**Proposed OceanaGold
Coronation North Project**

Assessment of aspects of the
application for resource consent

Prepared for
Otago Regional Council

Prepared by
Tonkin & Taylor Ltd

Figure 1: Approximate reasonable extent of area of influence of Coronation Pit Stage 5 (CP5) and Coronation North Pit (CNP) and likely effects on shifting the surface water recharge zone downstream.

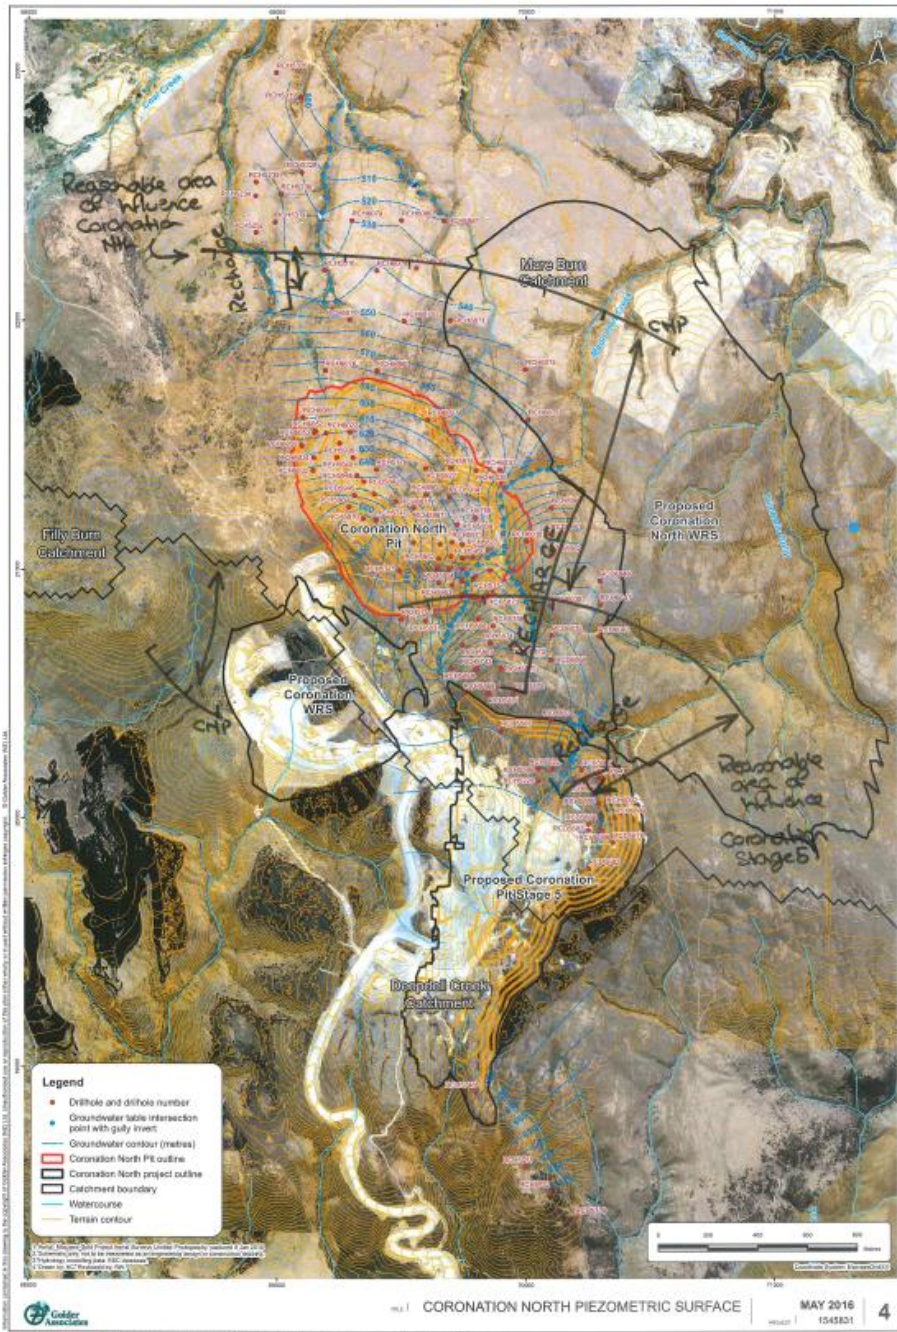
Figures D1, D2 and D3 of Appendix 5 show the extent of the effect of mining on groundwater levels, and the Applicant's assessment of the reasonable extent of groundwater level drawdown for Coronation Pit Stage 5 and CNP. In Figure 1 below, this is shown superimposed on the piezometric surface presented by the Applicant in Figure 4 of Appendix 5.

Figure 1 shows that lowering of the groundwater levels has the potential for recharge zones in each waterway to move further downstream, which in the case of the Coal Creek Catchment may be in the order of a couple of hundred metres, and for Maori Hen Stream may be up to 1000 m. The effects of this could be a reduction in baseflow at or downstream of these locations, a reduction in the length of stream/seepage habitat due to dewatering (where these are not directly physically impacted by other mining activities themselves), a reduction in allocable flows, and potentially a reduction in water available for the dilution of contaminants.
